# Z-69

\*\*\*\*\*

**ZONING COMMENTS:**

### **Z-69 TAKE 5 OIL CHANGE**

Sheet Description:  
**REZONING PLAN**  
**C-100**

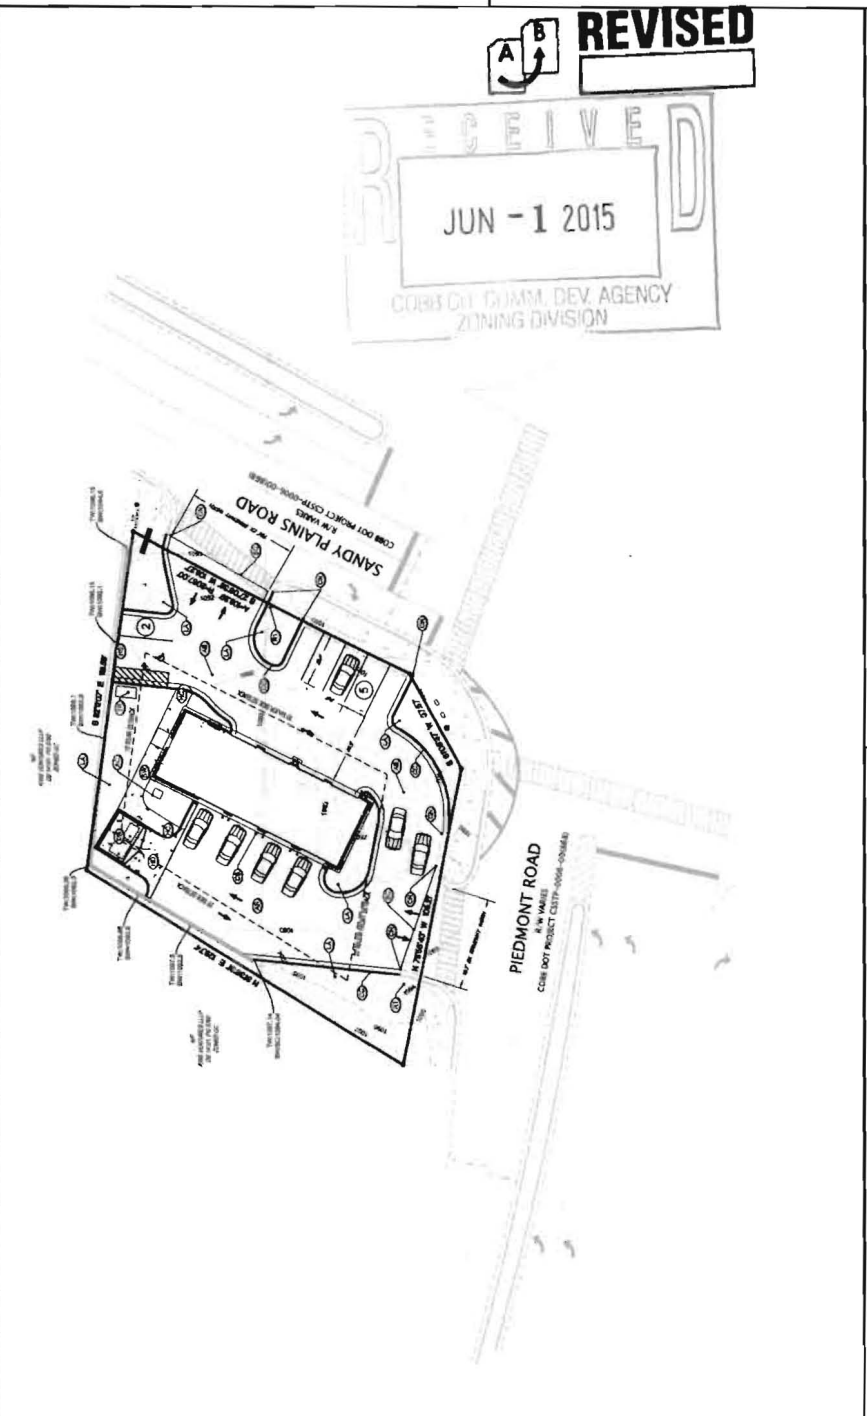
- Provide comprehensive hydrology/stormwater controls to include development of out parcels.
- Submit all proposed site improvements to Plan Review.
- Any **spring activity** uncovered must be addressed by a qualified geotechnical engineer (PE).
- Structural fill \_\_\_\_\_ must be placed under the direction of a qualified registered Georgia geotechnical engineer (PE).
- Existing facility.
- Project must comply with the Water Quality requirements of the CWA-NPDES-NPS Permit and County Water Quality Ordinance.
- Water Quality/Quantity contributions of the existing lake/pond on site must be continued as baseline conditions into proposed project.
- Calculate and provide % impervious of project site.
- Revisit design; reduce pavement area to reduce runoff and pollution.

- No Stormwater controls shown \_\_\_\_\_
- Copy of survey is not current – Additional comments may be forthcoming when current site conditions are exposed.
- No site improvements showing on exhibit.

1. This parcel is located at the northwest corner of Sandy Plains and Piedmont Roads. The site was previously a gas station and is currently being operated as a hand car wash facility.
2. Verification of proper removal and EPD closure certification of all underground storage tanks must be provided.
3. Although the site impervious coverage will be reduced from 93% (existing) to 78% (proposed) the site will still require that full stormwater management be provided.

Recommend replacing disturbed curb, gutter, and sidewalk along the Piedmont Road and Sandy Plains Road frontages.

- Site plan received by the Zoning Division on June 1, 2015, with the District Commissioner approving minor modifications;
- Allowance of variances as stated in the Zoning comments;
- District Commissioner to approve building architecture;
- Water and Sewer Division comments and recommendations;
- Stormwater Management Division comments and recommendations; and
- Department of Transportation comments and recommendations.
